Service Bulletin - June 2023

SAF Tire Pilot Plus™ (TPP) Inflation System

Tire Pilot Plus Safety Concern

Figure 4

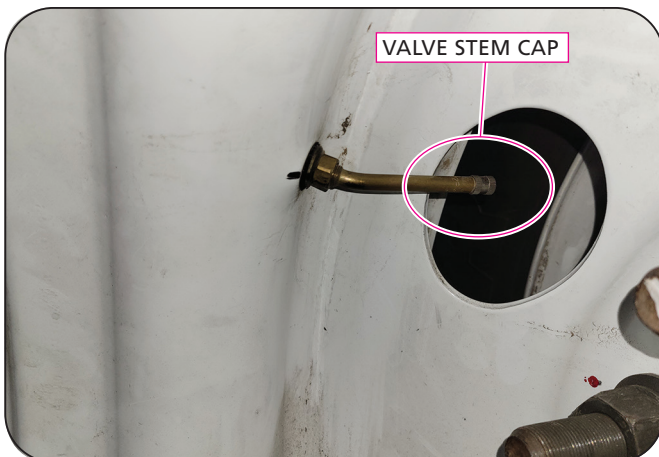
1. If determined to have an electronic regulator assembly with a white label, isolate the trailer air tank from its air supply and disconnect the 7-way power at the front of the trailer. Drain the air from the trailer air tank.
2. Loosen and remove the tire hoses by hand starting at the hubcap fitting (**Figure 3**). Tire hoses with black hose wrap should be disposed.
3. Install a valve stem cap on the tire valve stem (**Figure 4**).
4. Remove the tire hose fitting from the hubcap using a 15mm or 9/16" deep well socket (**Figure 5**). Install the 1/4" NPT pipe plug in the hubcaps. Install hand tight plus 2 turns or 25-30 lb-in (**Figure 6**).
5. Disconnect the air line from the PPV as illustrated (**Figure 7**).
